#	Date	Issue / Description
01	05/02/16	1ST PLANNING SUBMITTAL
02	09/15/16	2ND PLANNING SUBMITTAL

# METRO CENTER

**ALAMEDA PARKWAY & SABLE BLVD.  
AURORA, CO 80012**

**WOODBURY CORPORATION**

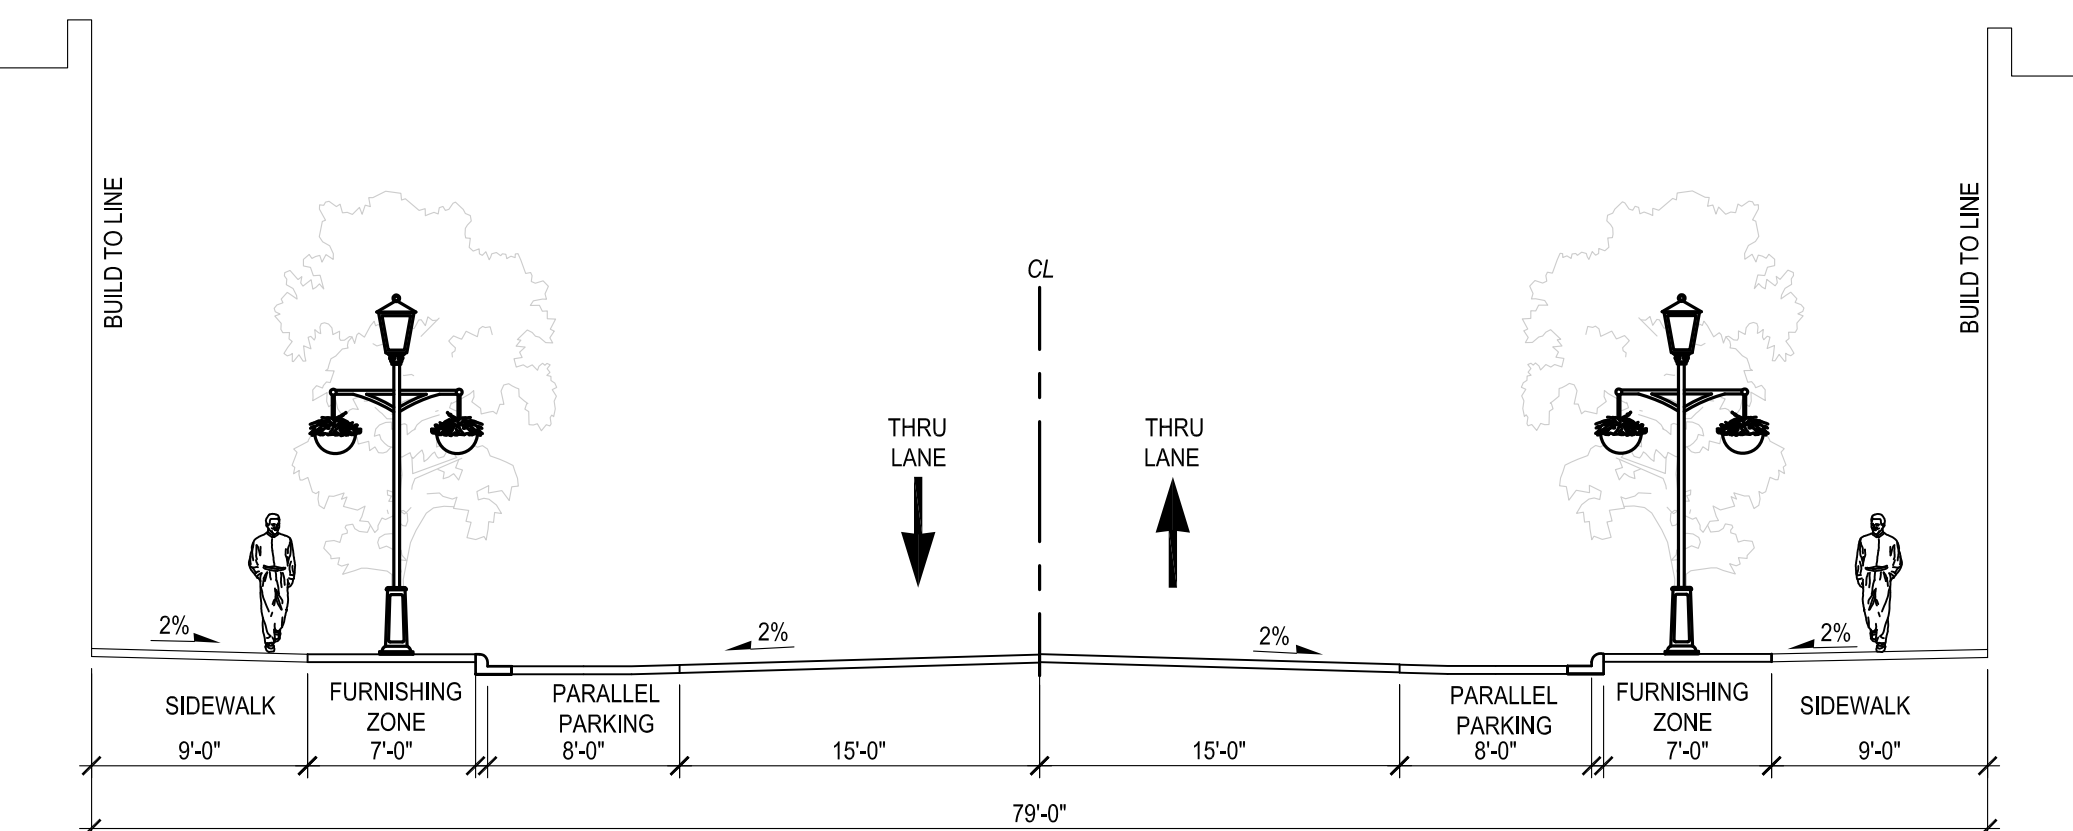
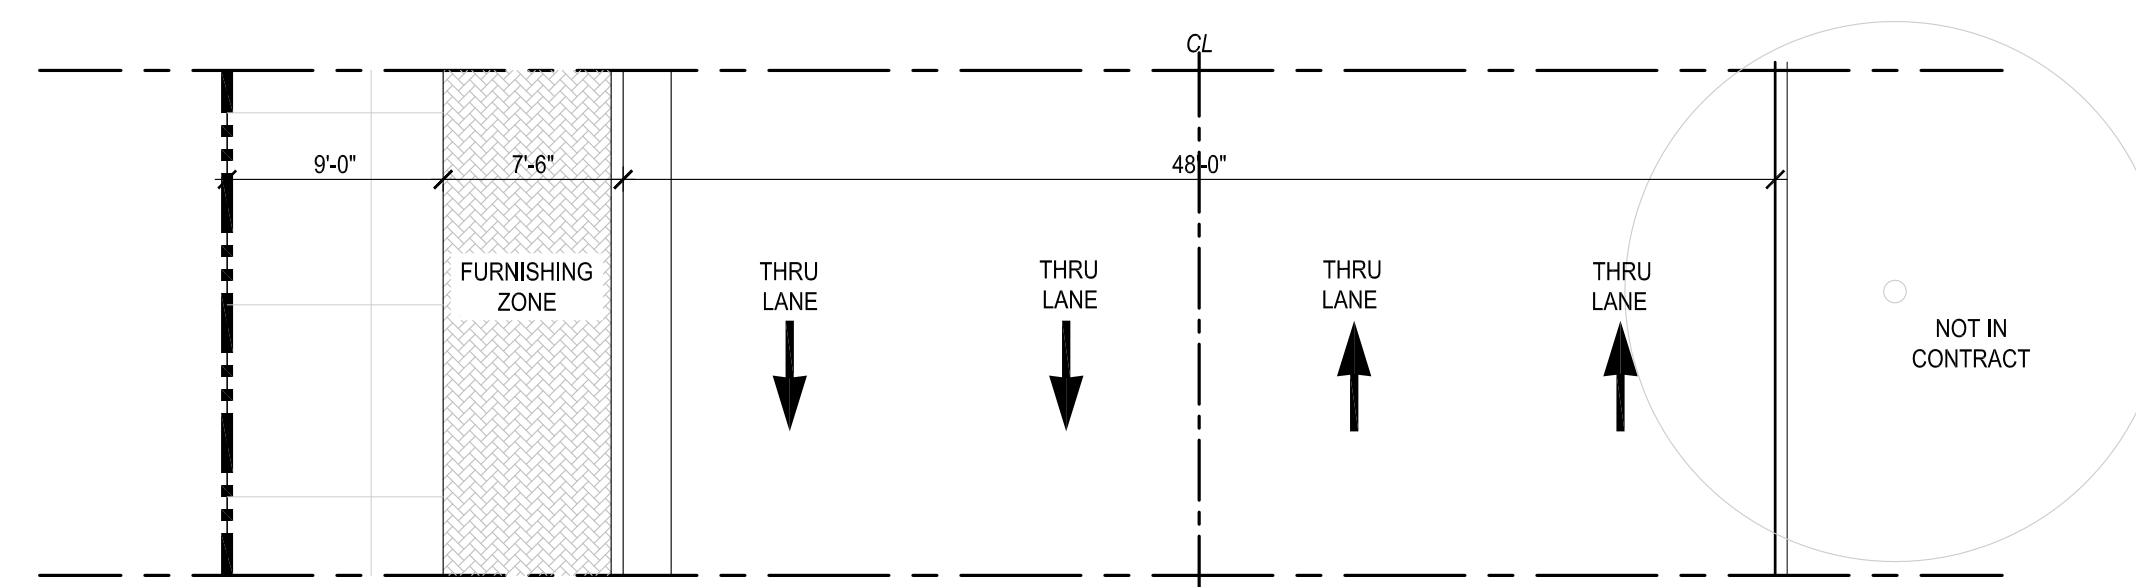
IT WOULD BE MUCH BETTER TO PLACE THE STRIPING FOR PARALLEL PARKING LIKE THIS SO YOU DON'T HAVE PEOPLE GETTING OUT OF THEIR CAR AND STEPPING ON THE PLANTS AROUND THE TREE.

Label what this is and provide a dimension. Should be 5'x10'

## DETAILS

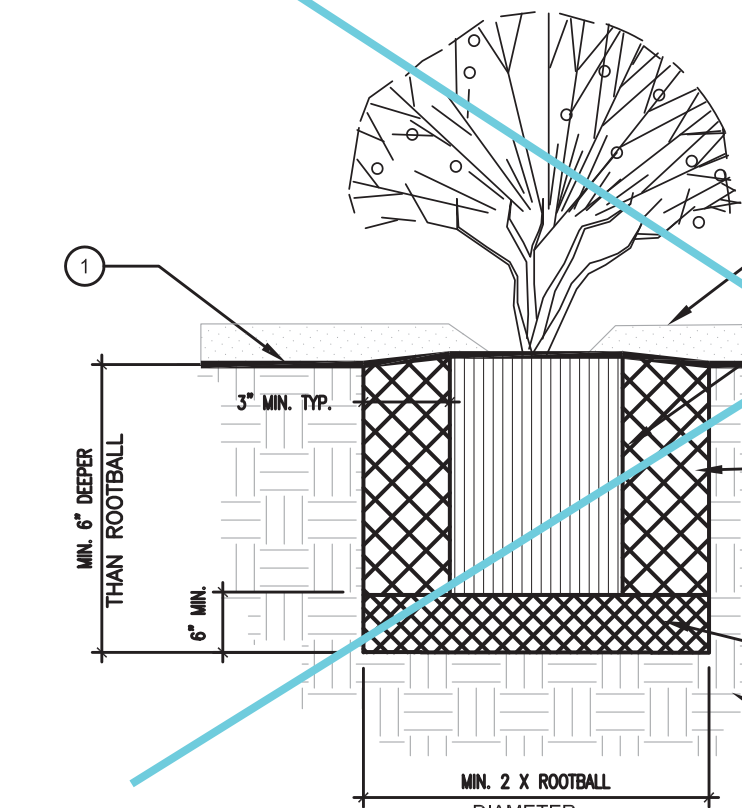
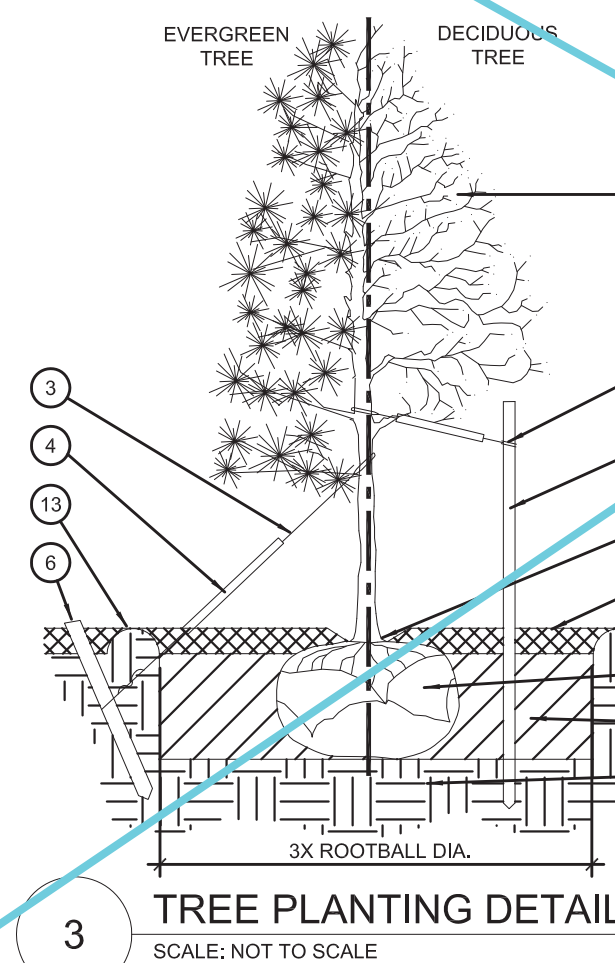
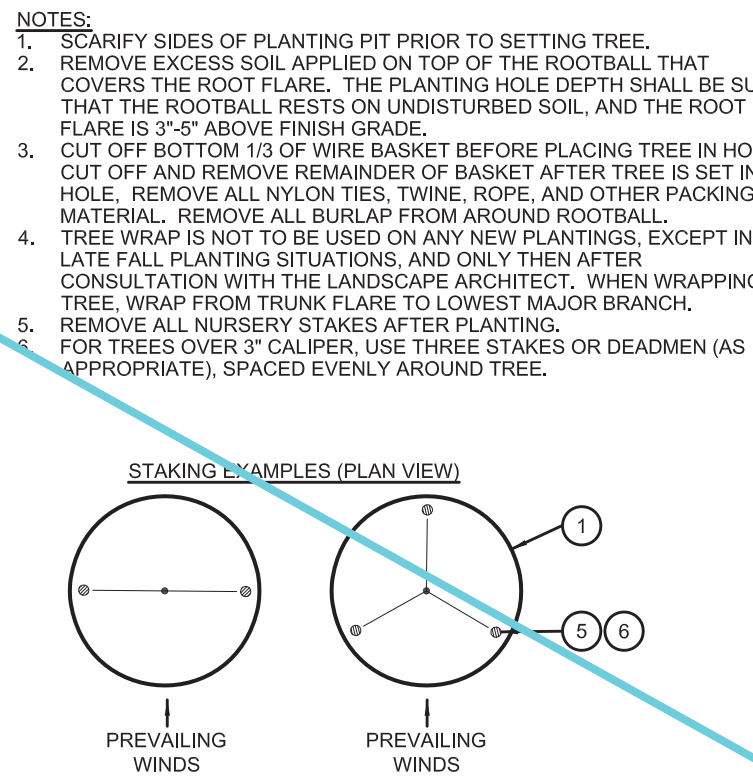
Some of the city's required landscape notes as found in the Landscape Reference Manual have been listed here, but some are missing. Please provide all required notes.

Show sight lines per COA STD Detail TE 13.1 at all intersections. Trees inside any sight triangles will need to be large trees on install to meet sight distance requirements (must be clear 3' to 7' vertically).

SIGHT TRIANGLES ARE NOW SHOWN AT INTERSECTIONS. TREES ARE NOT IN TRIANGLES, ADDITIONALLY, A NOTE HAS BEEN ADDED TO THE PLANT LEGEND THAT DECIDUOUS SHADE TREES AT SIZE SPECIFIED SHALL MEET THE CLEARANCE REQUIREMENT.

PLANS REVISED PER COMMENTS, EXCEPT WHERE ADDITIONAL RESPONSES/NOTES ARE PROVIDED.

ENLARGED LANDSCAPE PLAN  
PLANNING AREA 1

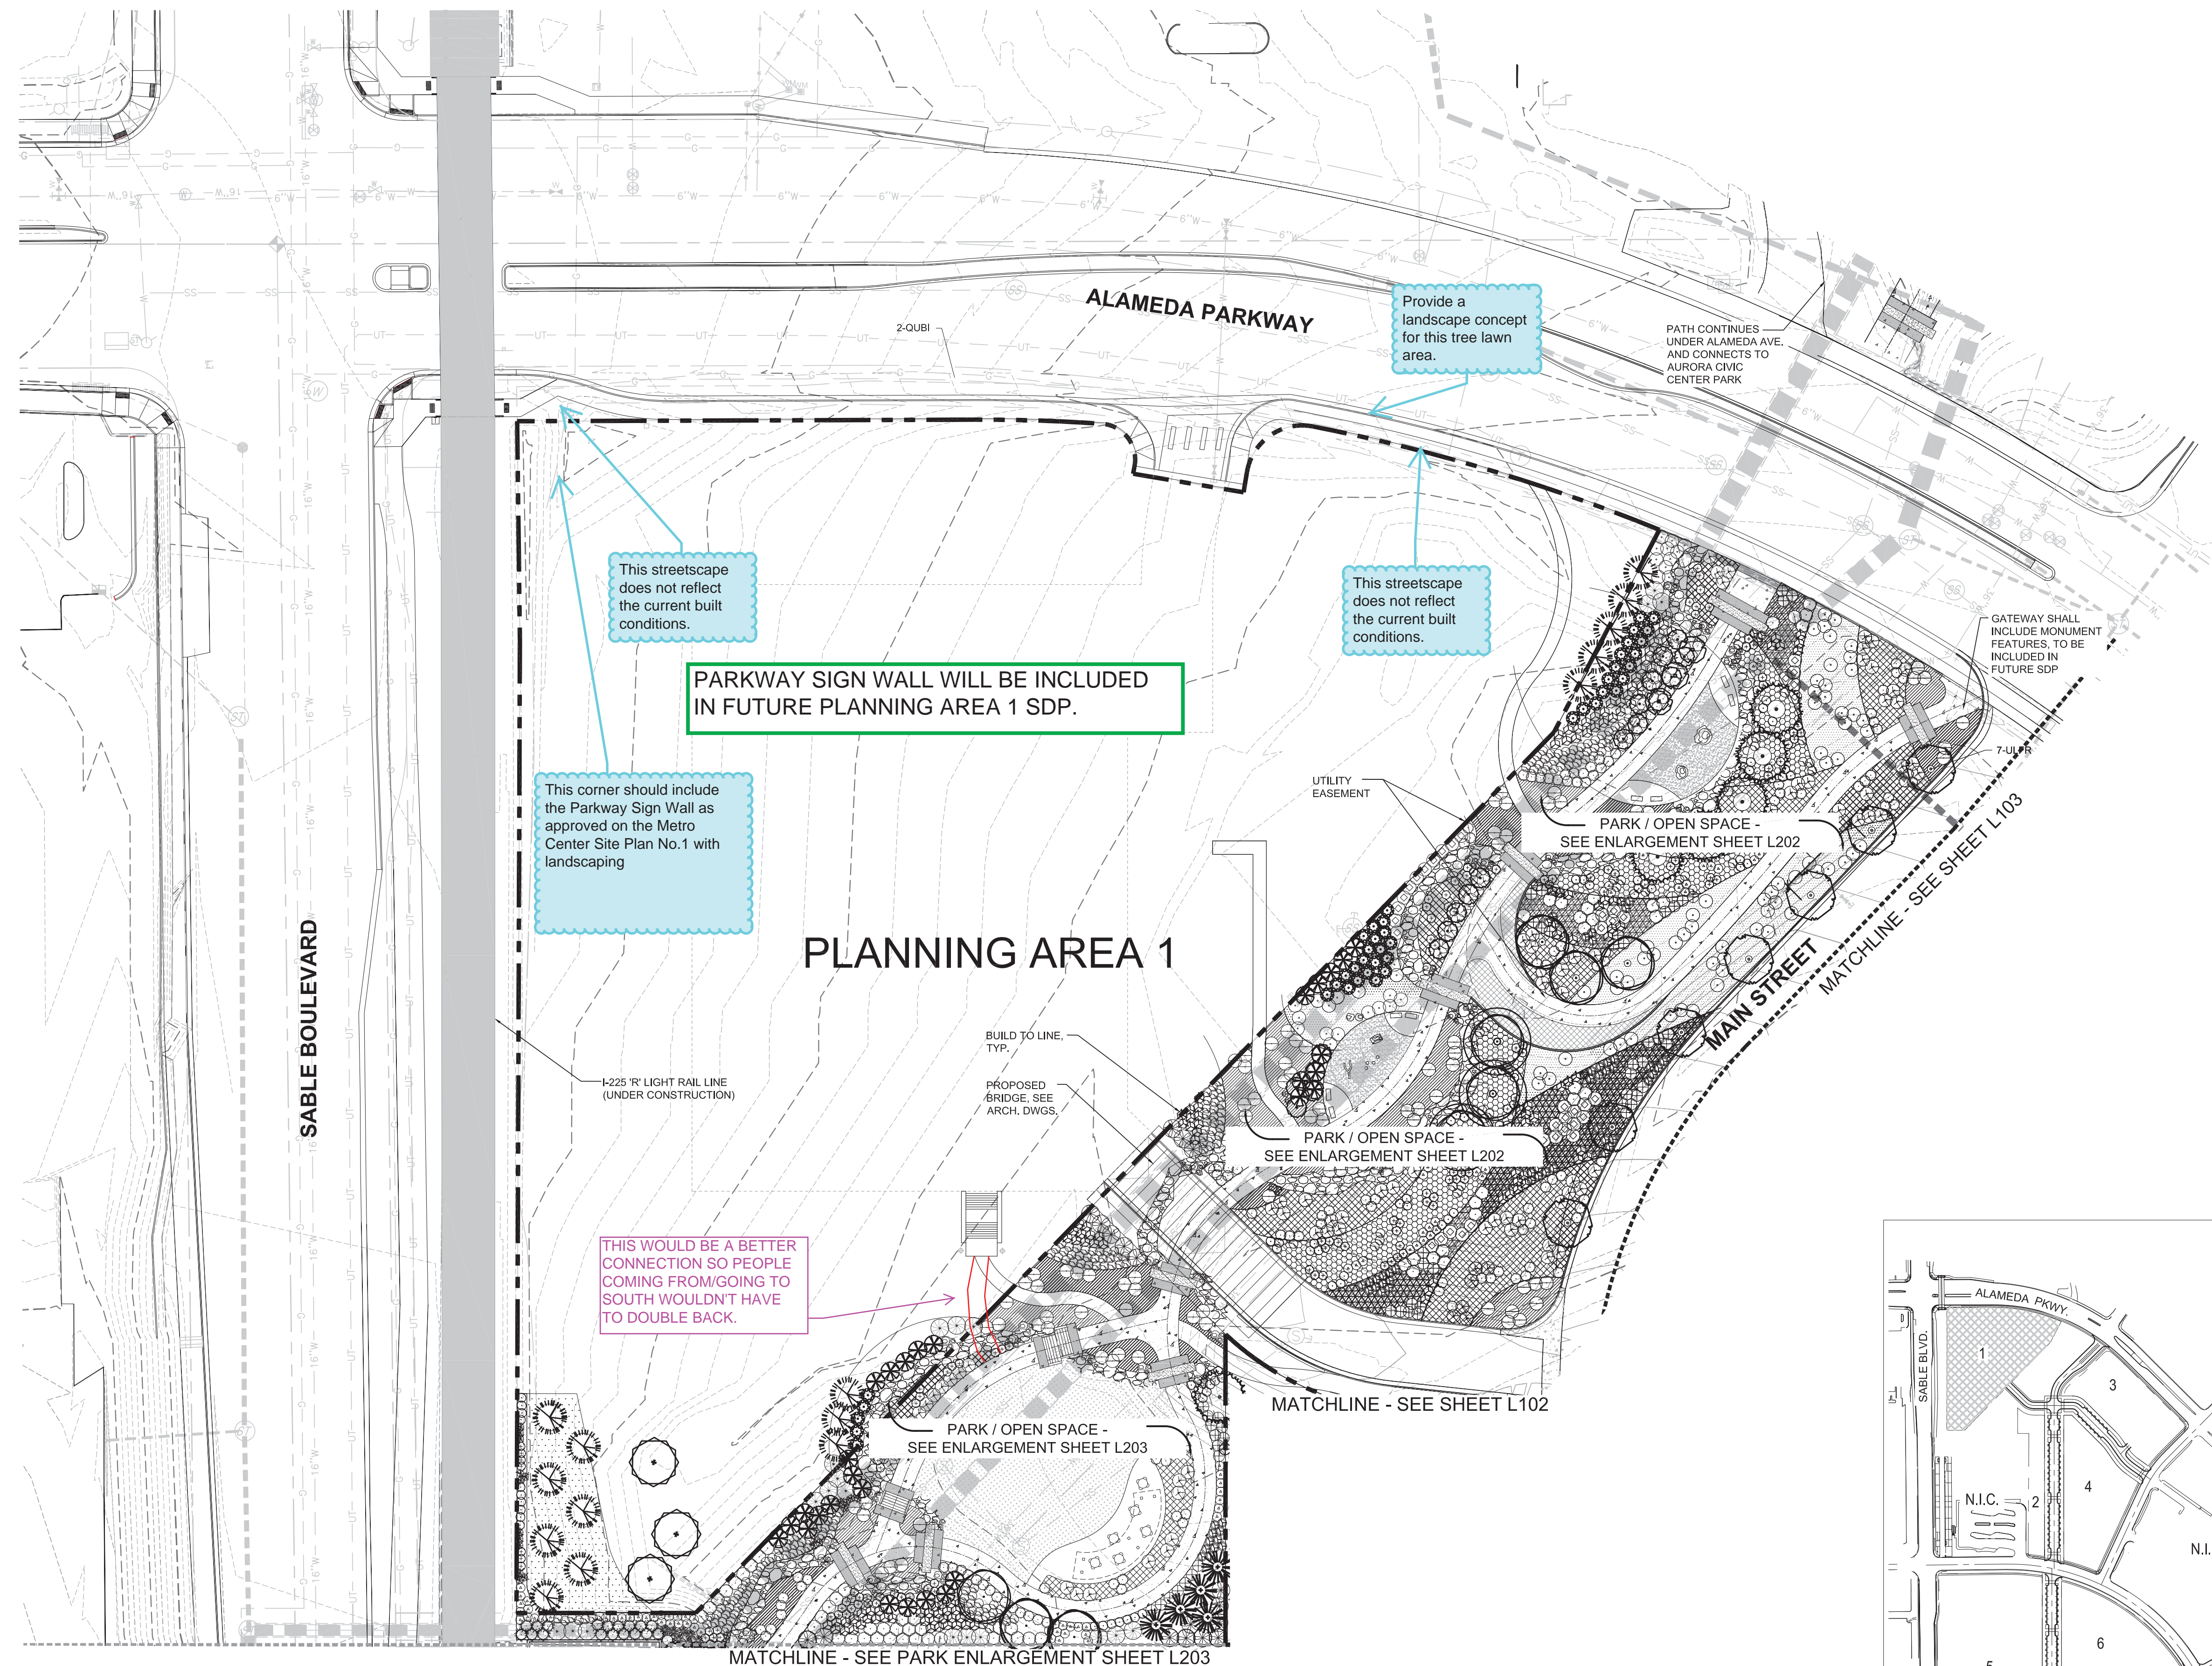
Are there existing trees being saved?  
If not, please remove these notes as  
they are not needed.

- Add a landscape legend to each landscape sheet per the Landscape Reference Manual. Include the plant symbology and hatches, lighting etc..

NO EXISTING TREES ARE TO  
REMAIN; PROTECTION NOTES  
REMOVED
